BAR #2020-00553

City Council  
May 15, 2021

**ISSUE:** Appeal of a decision of the Board of Architectural Review denying a Certificate of Appropriateness to install a small cell facility in the Parker-Gray District

**LOCATION:** Dominion Energy utility pole near 215 North Patrick Street parcel

## Site Plan

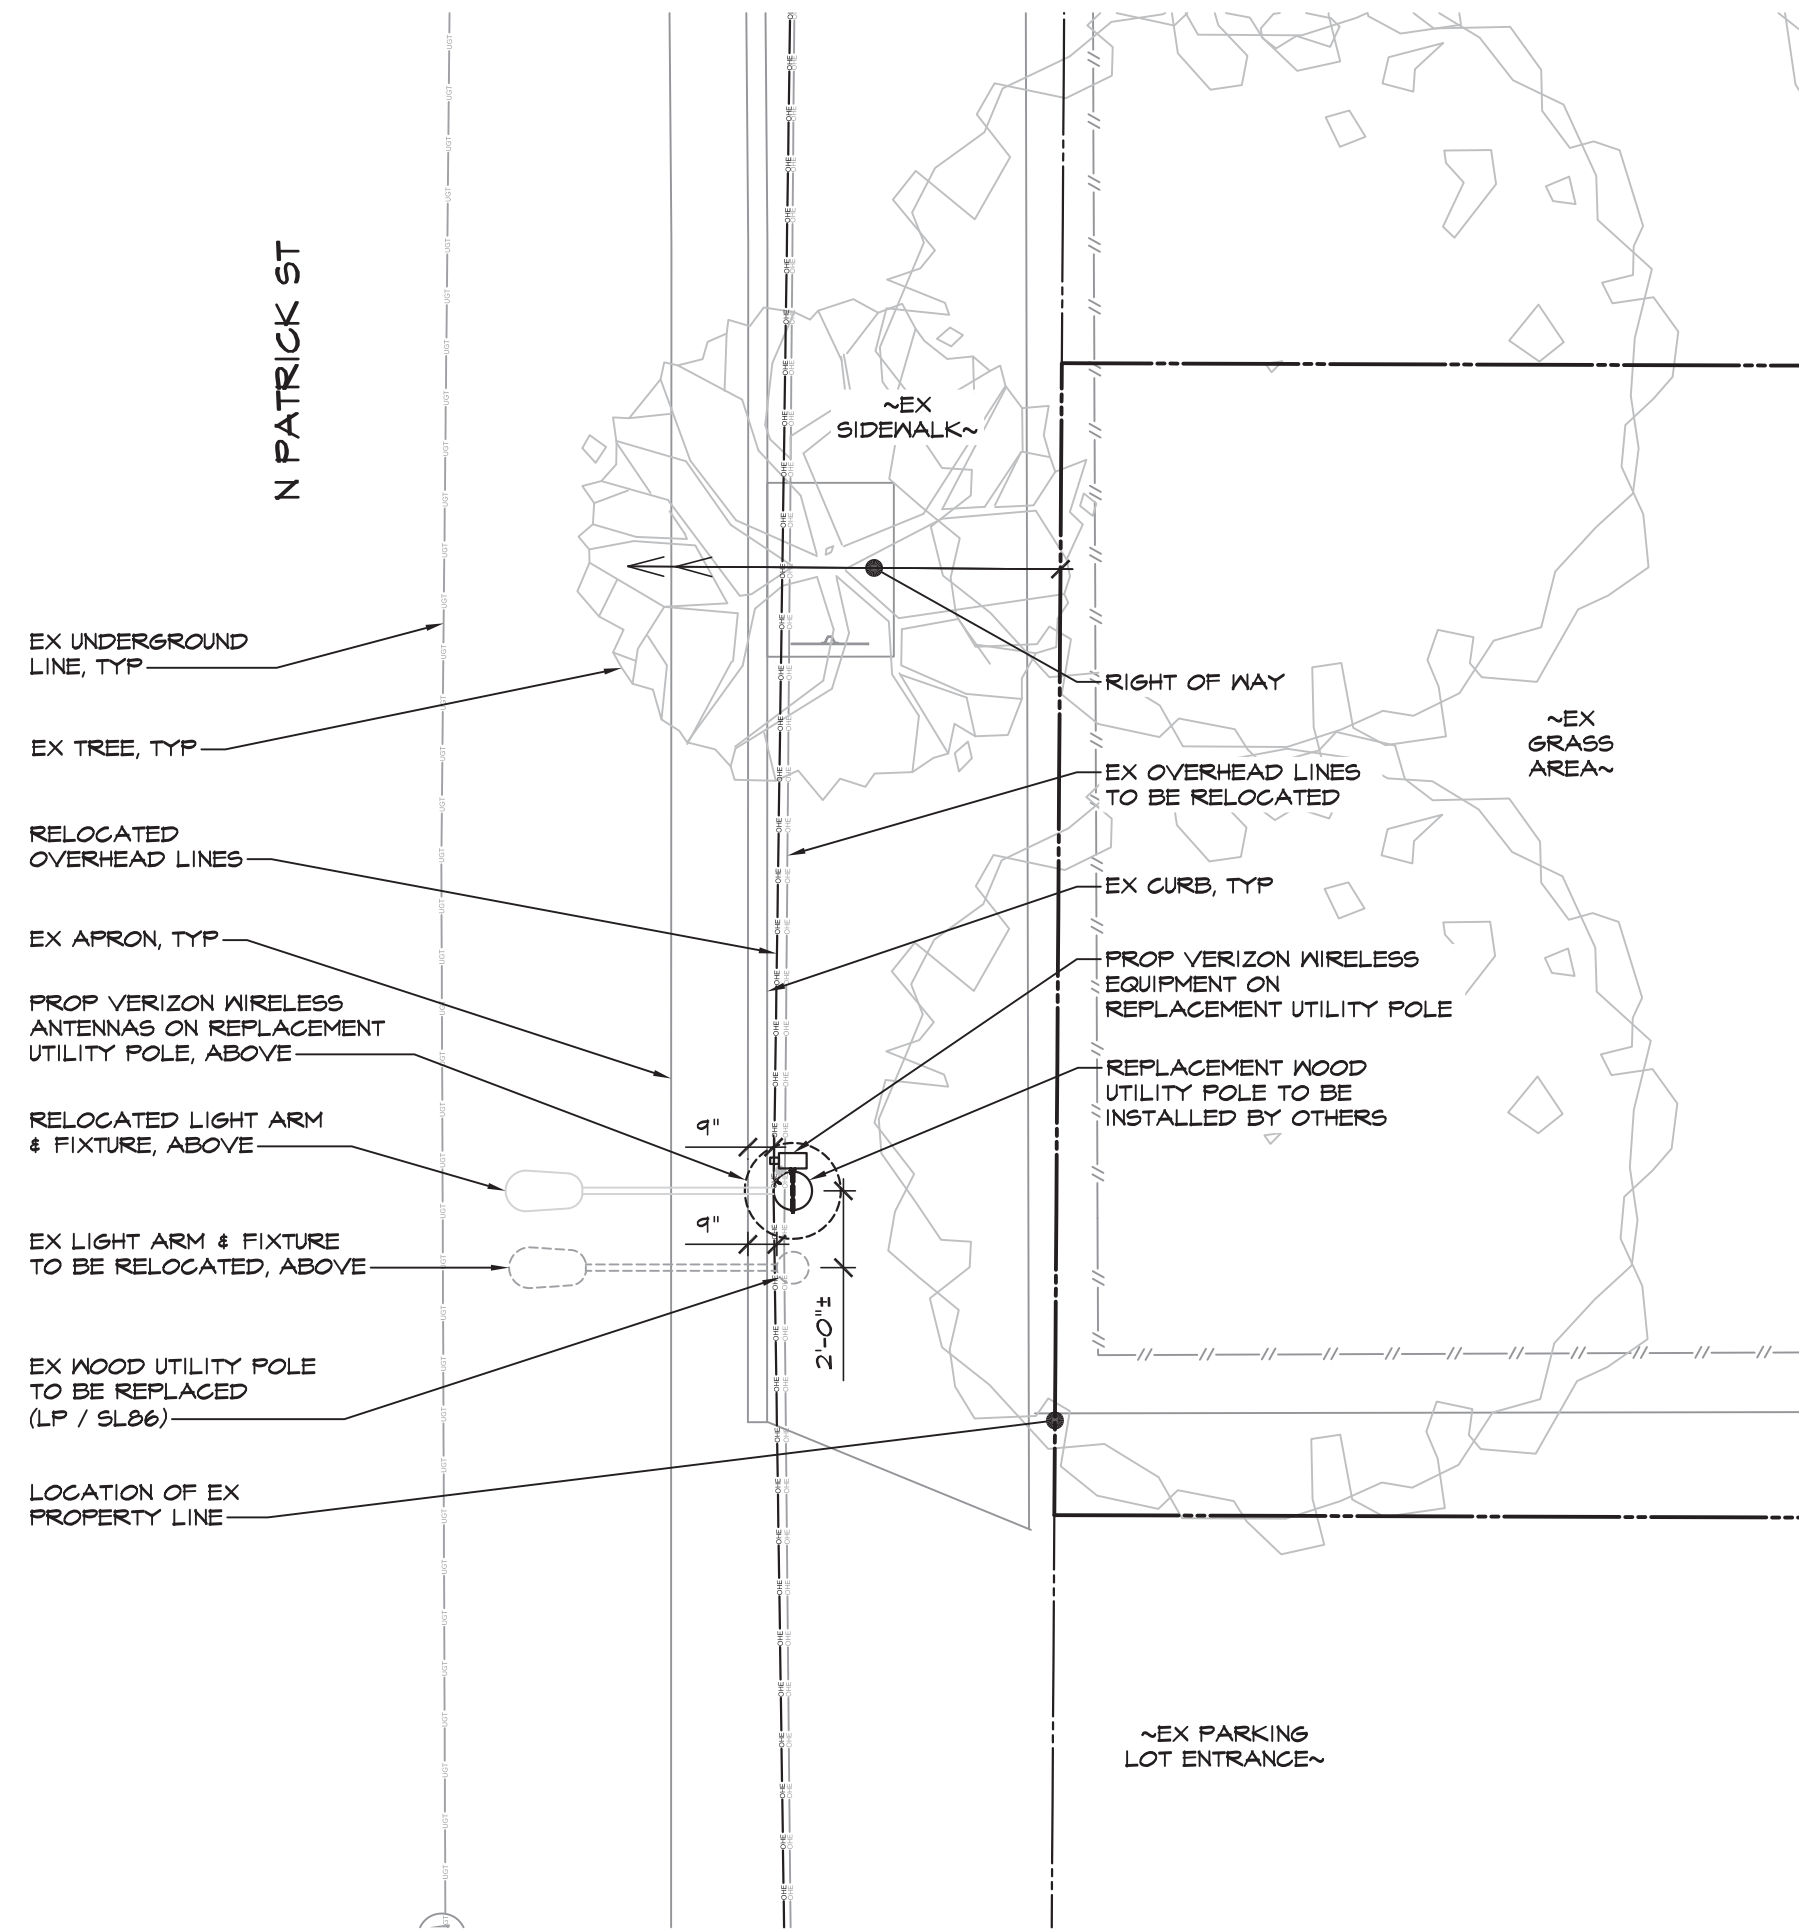
- Page 14 shows that there are only trees on the opposite side of 215; they did not mark the trees near the pole on private property. My neighbors have large Leyland Cypresses that grow along their fence; these types of trees can grow up to 70'. Will the poles be affected by the tree's crown, and will this require pruning or cutting them back? This will be an added expense to the homeowner and will affect the aesthetics of the tree.

- The trees' root systems are near the sidewalk, which will be disturbed by any new construction or digging for the new pole. Trees may not show signs of decline immediately, but statistically, trees that suffer root damage will decline over the years and may lead to death.

### Proposed View 1

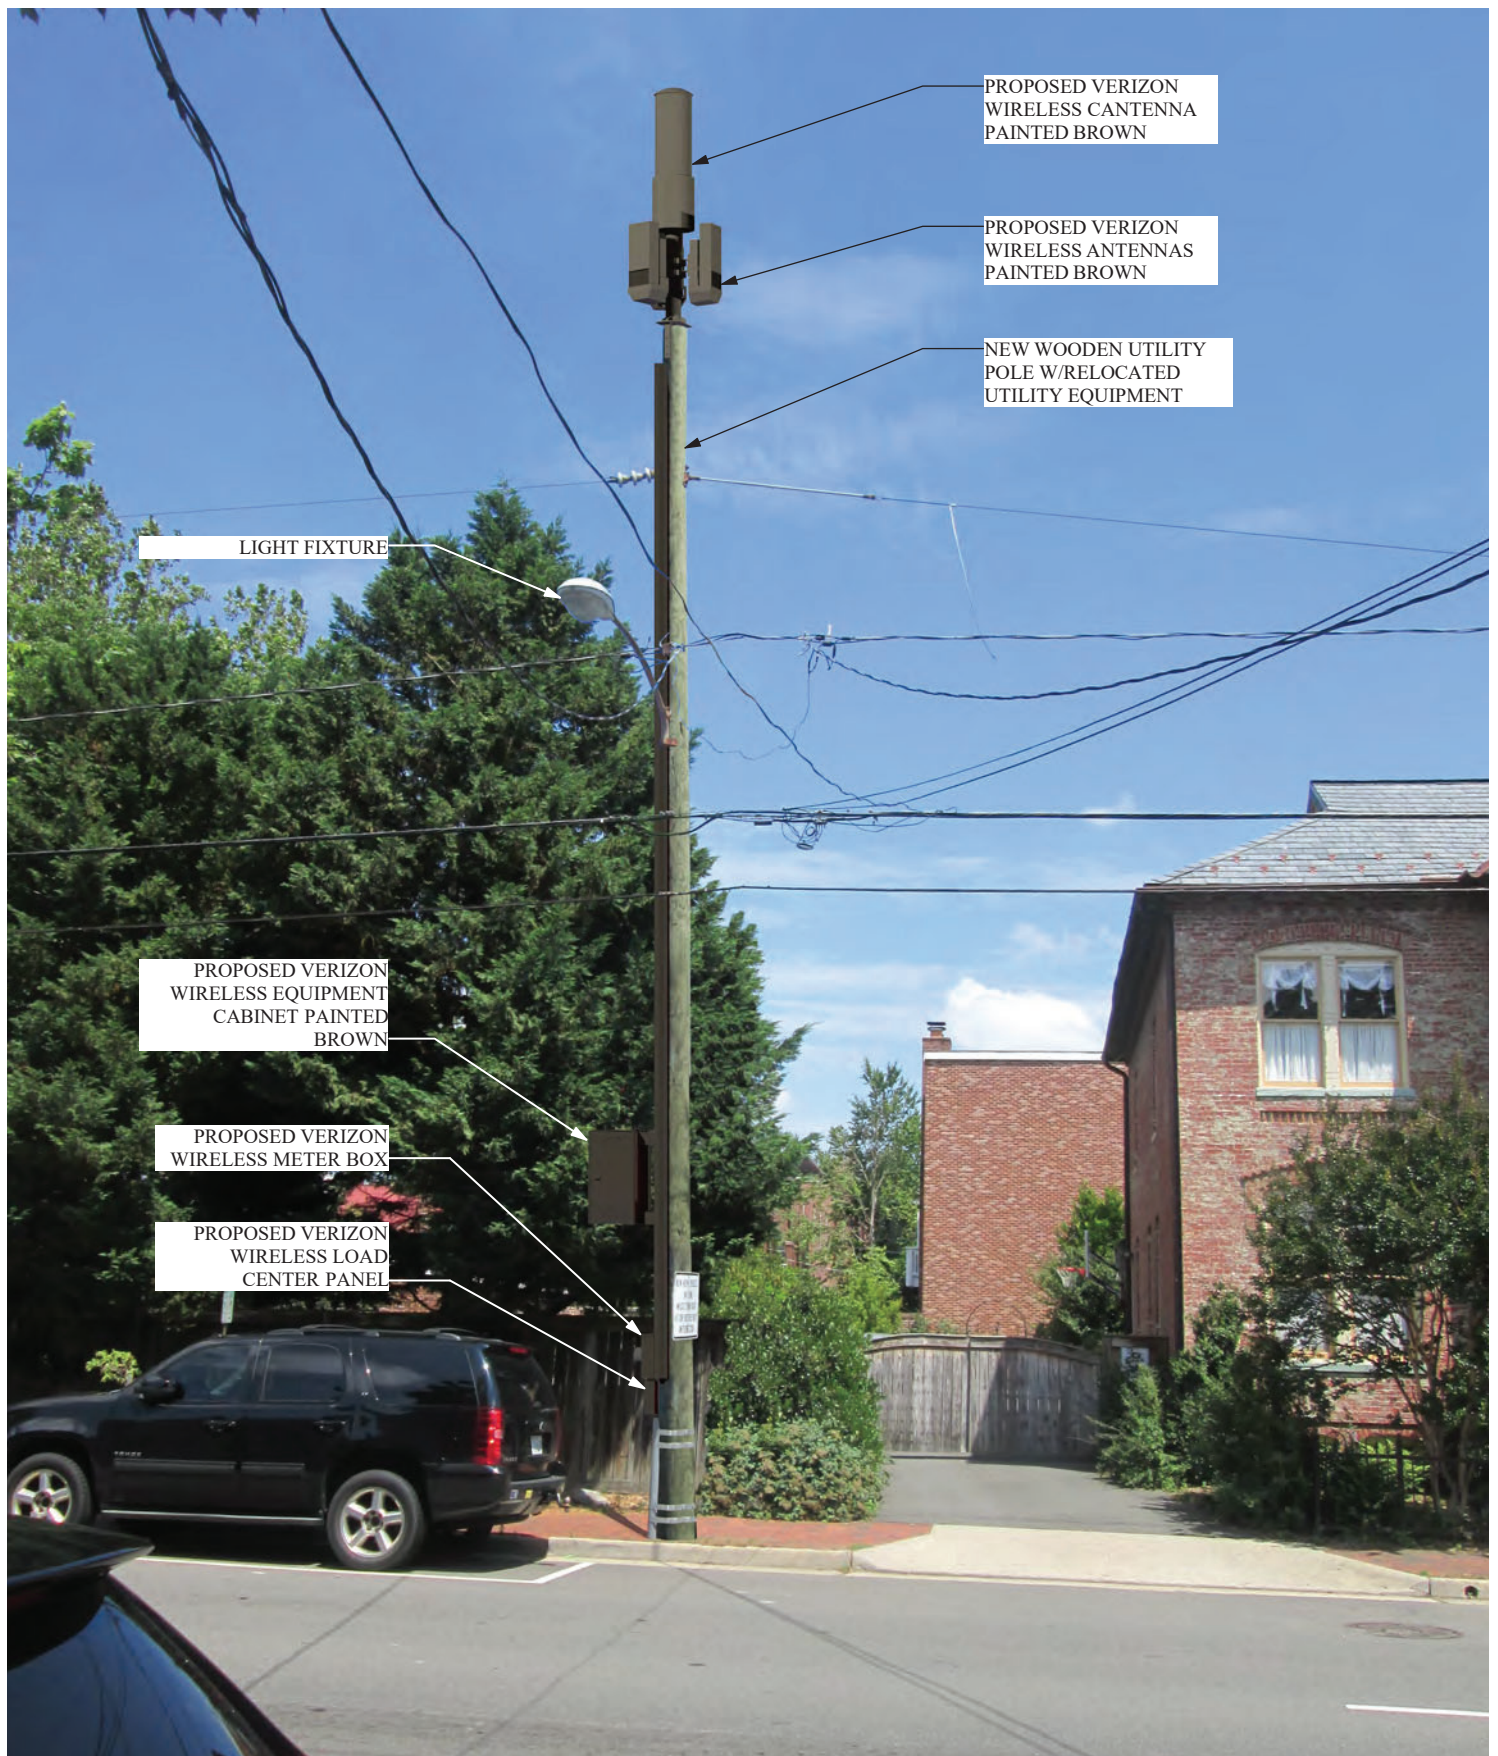
Ms. Sennott had questions about the importance of this block to the network overall plan, and also about the discrepancy on the maps showing the location of the pole since seemed to her that in the application's picture, the replacement pole is clearly to the south of the property line and in front of 211 North Patrick driveway. Mr. Schakola clarified that if the location is not approved, it might signify a gap in the intended service for the area. This particular location is also a capacity site which alleviates

Ms. Sennett had questions about the importance of this block to the network overall plan, and also about the discrepancy on the maps showing the location of the pole since seemed to her that in the application's picture, the replacement pole is clearly to the south of the property line and in front of 211 North Patrick driveway. Mr Schakola clarified that if the location is not approved, it might signify a gap in the intended service for the area. This particular location is also a capacity site which alleviates overburdened small cell facilities nearby, where the demand for service is intensified especially now that more people are working from home due to COVID-19.
